# Waterfront Overlay Public Comments

Last Revised February 24, 2021

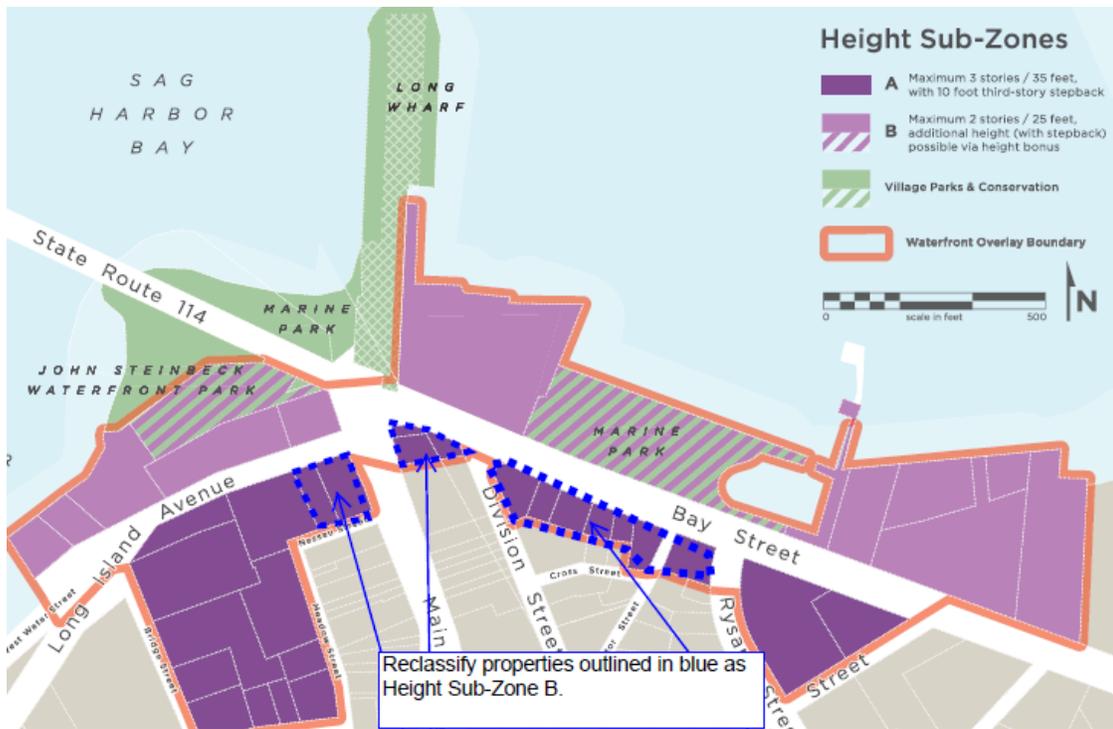
The draft graphics do not indicate/address chimneys, mechanical equipment and other rooftop penetrations. Concern was expressed that the proposed language for 5.3.4.B may be excessive as it permits numerous roof items and the commentor asked how the 20% mechanical exemption would be calculated.

- FEMA flood zone requirements should allow for an increased maximum building height.
- Recommended increasing the height of Civic buildings to 40' (currently 35').
- Proposed measuring height to the midpoint of a pitched roof.
- Proposed an increase for mechanical equipment coverage to 60% of roof area.

Section 5.3.4.B requires that building height is measured in feet from grade to the top of the roof surface of a flat roof or to the peak of a pitched roof. This height calculation does not include the following architectural and structural features, so long as such features do not exceed 125% of the permitted height of the structure on which the feature is placed, and does not occupy more than 20% of the total area of the roof:

1. A code-required railing or parapet.
2. Mechanical equipment, placed and screened in accordance with Section 3.3.5.A.
3. On any public or semipublic building, a spire, cupola, dome, belfry, or clock tower.
4. Flagpole, chimney, flue, elevator, stair bulkhead, skylight, or fire escape.
5. Radio or television tower, transmission line or tower, or similar structure necessary as a public service facility, only after approval as a special exception use by the Planning Board.

1. Reevaluate the requirements for mechanical equipment on rooftops and consider limiting the maximum height allowed for mechanical equipment.
2. Alter the boundary of Height Sub-Zone B (max. 2 stories, 25' feet) to include additional properties, as shown in the image below, that are across the street from existing parks or view corridors.
